Title - Sujet Drydocking CCGS Alfred Needler	
Solicitation No. - N° de l'invitation F5561-171133/A	Amendment No. - N° modif. 002
Client Reference No. - N° de référence du client F5561-17-1133	Date 2017-11-24
GETS Reference No. - N° de référence de SEAG PW-\$HAL-311-10240	
File No. - N° de dossier HAL-7-79152 (311)	CCC No./N° CCC - FMS No./N° VME
Solicitation Closes - L'invitation prend fin at - à 02:00 PM on - le 2017-12-04	Time Zone Fuseau horaire Atlantic Standard Time AST
F.O.B. - F.A.B. Specified Herein - Précisé dans les présentes	
Plant-Usine: <input type="checkbox"/> Destination: <input type="checkbox"/> Other-Autre: <input checked="" type="checkbox"/>	
Address Enquiries to: - Adresser toutes questions à: Dunne, Dave	Buyer Id - Id de l'acheteur hal311
Telephone No. - N° de téléphone (902) 401-4294 ()	FAX No. - N° de FAX (902) 496-5016
Destination - of Goods, Services, and Construction: Destination - des biens, services et construction:

Solicitation Amendment 002 is issued to provide additional vessel transfer costs in paragraph 2.9.2(ii), distribute the bidders' conference minutes, distribute the pricing data sheet, introduce three (3) new specification items and provide re

Piping schematic for new grey water tank.

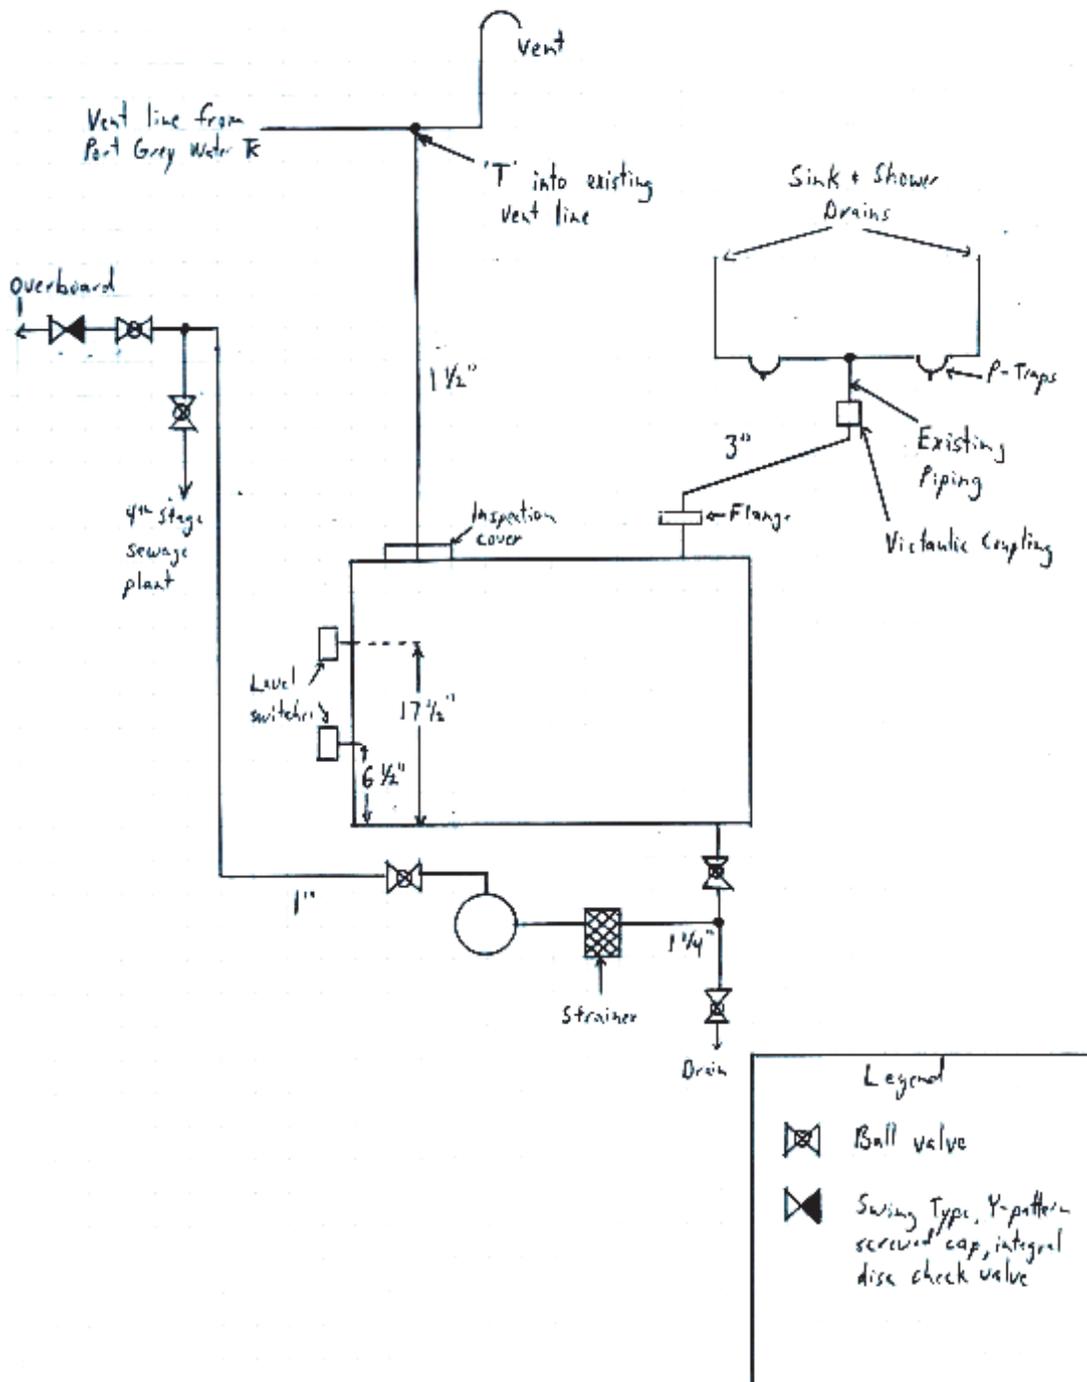
4. Contractor must modify the starboard grey water piping arrangement as per the drawing in section 3.1 below.
5. All pipes, flanges, valves, wire, pump starter box/controller, and consumables required to complete this installation shall be contractor supplied. Supplied piping shall be schedule 40 black iron.
